A428 Black Cat to Caxton Gibbet improvements

TR010044

**9.20 Applicant's comments on other parties'
responses to first round of written questions**

Regulation Number	Rule 8(1)(b)
Planning Inspectorate Scheme Reference	TR010044
Document Reference	TR010044/EXAM/9.20
Author	A428 Black Cat to Caxton Gibbet improvements, Project Team, National Highways

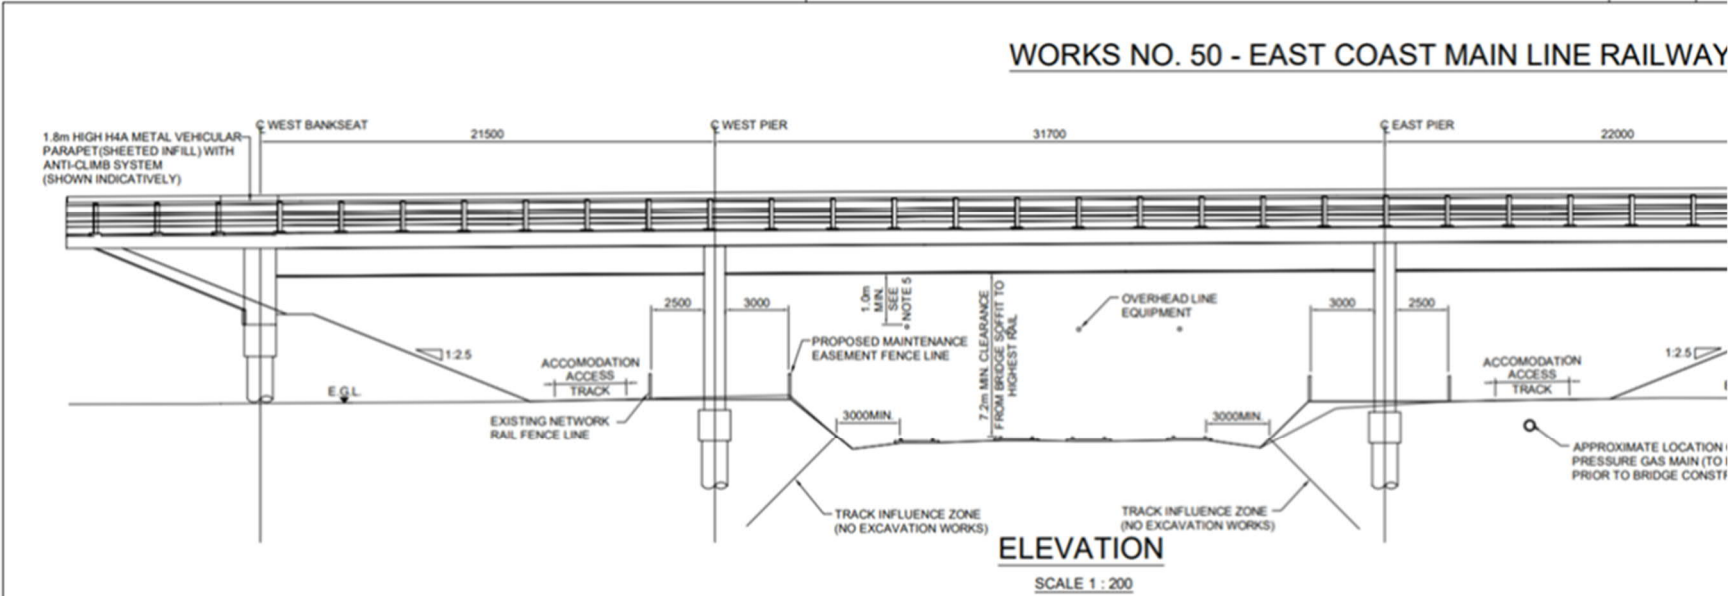
<p>CCC/HDC/SCDC (REP1-051):</p>	<p>The Councils refer to section 6 of their Written Representation in addition to the points made below.</p> <p>Policy LP 16 of Huntingdonshire's Local Plan to 2036-7 sets out the expected approach for new development in the District in relation to Sustainable Travel. It is considered that there are a number of instances within Huntingdonshire where the proposed development may not meet policy LP16. Whilst it is acknowledged the policy is geared towards planned development it does state 'all new development' and therefore is pertinent in assessing the A428 development proposal.</p> <p>In considering whether the A428 proposals meet Policy LP16 of the Local Plan, we have looked at each element of the policy in turn.</p> <p>a) opportunities are maximised for the use of sustainable travel modes It is noted that the proposals seek to maintain the existing public rights of network where possible. It is concerning, however, that the proposals fail to maximise the opportunities for use of sustainable modes. For example, routes that had previously been indicated as shared use paths in earlier iterations of the design are now downgraded to paths or removed. This is detailed in comments in this section in relation to the specific points on each affected route. In addition, the Councils are concerned that due to the design of routes not meeting the appropriate standards that this could deter some users and as such does not maximise the opportunities.</p> <p>b) its likely transport impacts have been assessed, and appropriate mitigation measures will be delivered, in accordance with National Planning Practice Guidance. CCC, as Local Highway Authority, has assessed the submitted Transport Strategy and related documents. It is understood that there are aspects of the transport impacts that present concerns for NMU and public rights of way. For example, at the new roundabout junctions at Cambridge Road St Neots, suitable crossings have not been designed into the scheme; and traffic levels and speeds are expected to rise in parts of the surrounding network, impacting on the ability of non-motorised users to cross or use busy sections safely, e.g. Toseland Road. It is considered that, as a consequence, elements of the proposals do not accord with National Planning Practice Guidance or LP Policy LP16.</p> <p>c) safe physical access from the public highway can be achieved, including the rights of way network where appropriate</p>

No.	Question/Applicant Comment
	<p>As noted above there are aspects of the scheme design that are cause for concern in relation to safe access of the public highway network, as detailed elsewhere in this joint response. The revisions set out will overcome these concerns and ensure that this aspect of LP Policy LP16 is complied with.</p> <p>d) any potential impacts on the strategic road network have been addressed in line with Department for Transport Circular 02/2013 and advice from early engagement with Highways England</p> <p>There is currently concern that the impacts have not been appropriately addressed.</p> <p>e) there are no severe residual cumulative impacts.</p> <p>The Councils are concerned that the level of severity of residual cumulative impacts may be incorrectly assessed in the Environmental Statement and would urge the applicant to revisit this.</p> <p>¹⁷ https://huntingdonshire.gov.uk/media/3872/190516-final-adopted-local-plan-to-2036.pdf</p>

<p>Applicant Comment:</p>	<p>The Applicant has made comments on this in the Applicant's Comments on Written Representations [TR010044/EXAM/9.21], refer to [REP1-048].</p> <p>e) Chapter 15, Assessment of cumulative effects [APP-084] of the Environmental Statement presents a comprehensive assessment of the likely significant combined and cumulative environmental effects of the Scheme following the methodology set out in the Design Manual for Roads and Bridges (DMRB) LA 104 and the Planning Inspectorate's Advice Note Seventeen. The significance of effect ratings ascribed by the Applicant are considered to be accurate and representative of the interactions that would occur between the Scheme and the other plans and projects identified and assessed.</p>
<p>Freeths LLP on behalf of Central Bedfordshire Council (REP1-054 and REP1-055):</p>	<p>There is scope to future proof provision for NMU's by adding in sufficient space for pedestrian / cycle provision where structures are to be delivered as part of the scheme.</p> <p>Specifically, sufficient additional width is requested on the deck of the Barford Road bridge to accommodate pedestrian and cycle provision and sufficient retained width is requested passing under the East – Coast Mainline Bridge to enable future pedestrian and cycle provision.</p> <p>Rights of Way is keen to see an improved rights of way network as part of the scheme's delivery – see attached which is a joint Beds Borough/CBC proposal for improving the rights of way network in Tempsford and the surrounding area.</p> <p>Improvement of the rights of way network is in line with government policy as stated in the National Policy Statement: "In delivering new schemes, the Government expects applicants to avoid and mitigate environmental and social impacts in line with the principles set out in the NPPF and the Government's planning guidance. Applicants should also provide evidence that they have considered reasonable opportunities to deliver environmental and social benefits as part of schemes."</p>

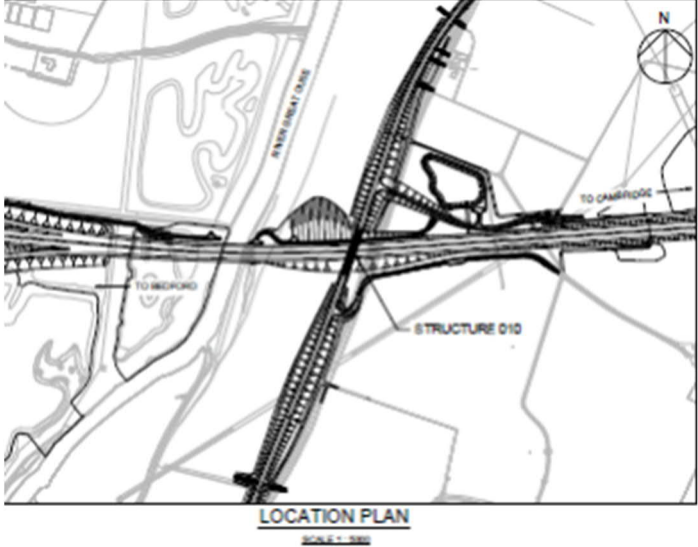
Rupert Goodings on behalf of CTC Cambridge (REP1-059):	<p>The CTC Cambridge response to the written question and the Applicants comments on this response are set out in Appendix B of this document.</p>
Applicant Comment:	<p>See Appendix B of this document.</p>
Camcycle (REP1-053):	<p>The Camcycle response to the written question and the Applicants comments on this response are set out in Appendix C of this document.</p>

No.	Question/Applicant Comment
Applicant Comment:	See Appendix C of this document.
<p>Q1.11.6.2 WCHAR Survey data</p> <p>The TA [APP-242, Section 2.21] explains that no new pedestrian, cyclist or equestrian usage data has been collected since July and August, 2016. Do LHAs and IPs consider that the information provided gives an acceptable and up to date picture of current usage by walkers, cyclists and horse-riders of the local road and PRow network?</p>	
British Horse Society (REP1-093):	<p>The BHS believes that data collected in July and August 2016 would need to be recollected to show an up-to-date picture of current usage by walkers, cyclists and horse riders of the local road and PRow network. Since 2016 the number of users will have increased especially due to the coronavirus pandemic which needs to be reflected in this information. However, as mentioned previously, usage surveys do not reveal the extent of suppressed demand. Provision of linking paths and safe crossings together with connectivity of the network, could impact hugely on usage. In some ways, low equestrian usage is more likely to reflect a poor network rather than a lack of horse riders wanting to use the routes. Data showing the numbers of horses in the vicinity and therefore potential usage, should be included along with the actual usage data.</p>
